# ADDENDUM No. 1

RFP No. 22-43

## WTP Sodium Hypochlorite Tank Replacement

## FRP TANK ACCESS LADDER DETAIL

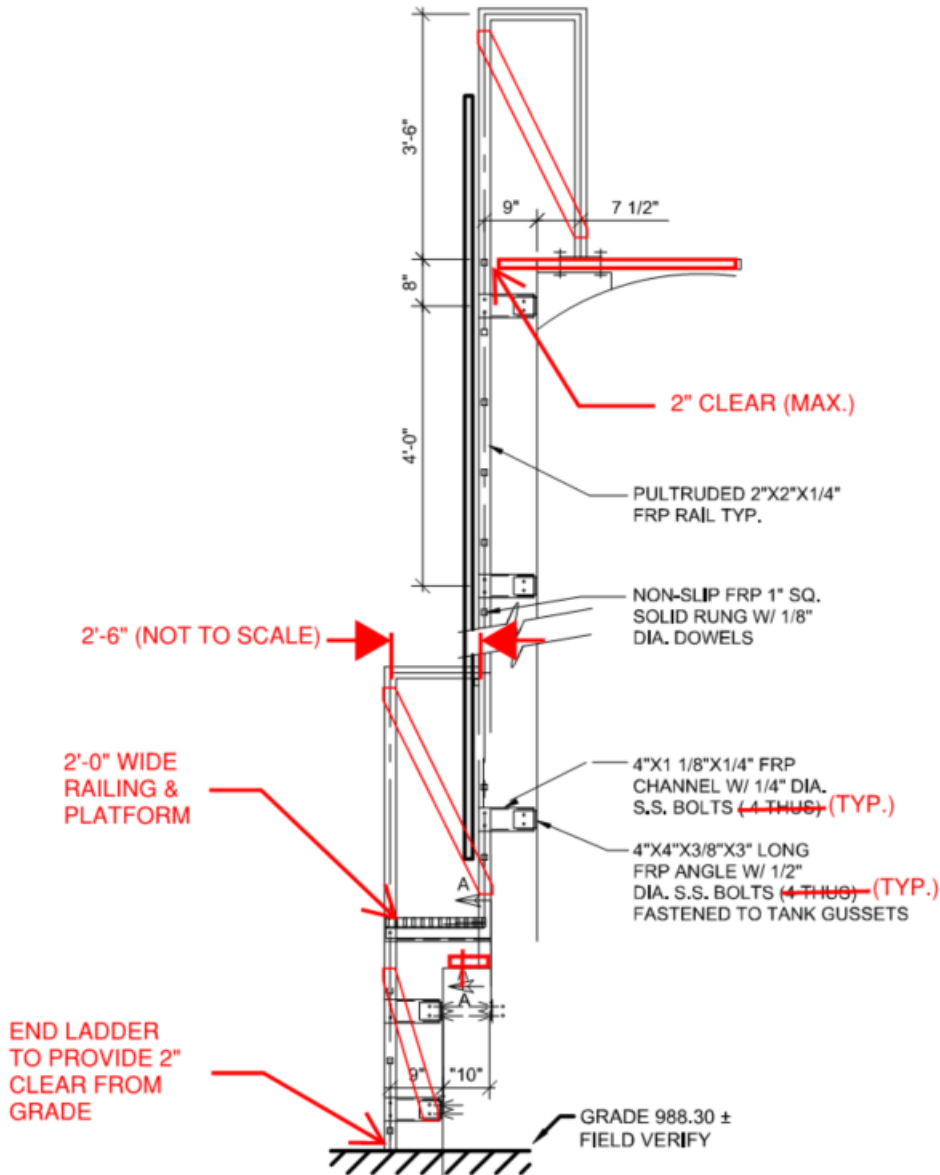
FRP Tank Access Ladder Detail. Replace ladder section with the attached detail.
